TI_2325: UL safety PCB A33

iVario & iVario Pro
Regional validity: North America

21.12.2023

PCB A33 on I/O PCB A10 (2-XS and 2-S):

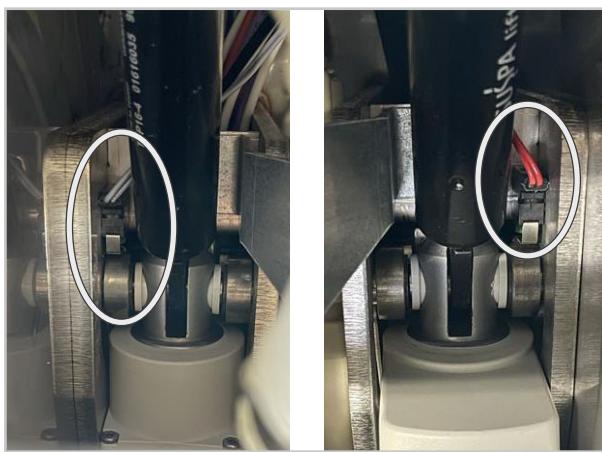
Since 6 November 2023, all units for the USA and Canada markets have been equipped with an additional "UL safety" PCB A33. This additional PCB is mounted directly on the I/O PCB A10 and connected to the X138 motor connection and the X139 PT1 and PT2 connectors.

The 24V power supply is split to supply the two PCBs A10 and A33. The pulse generator is now connected to the PCB A33.

Intermediate connection of the micro switches XS31:

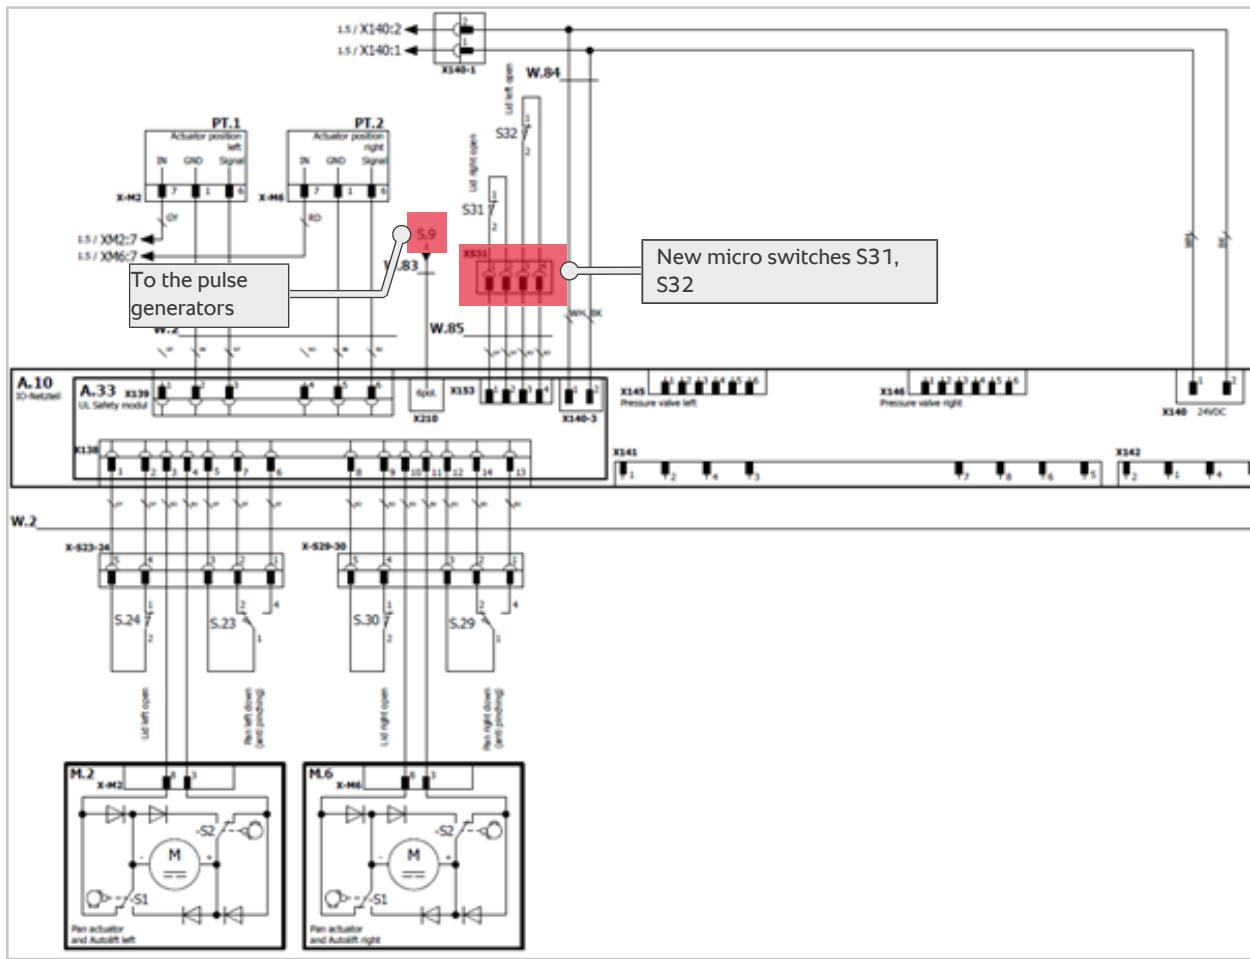
New micro switches on the motor wings (only for 2-XS and 2-S units):
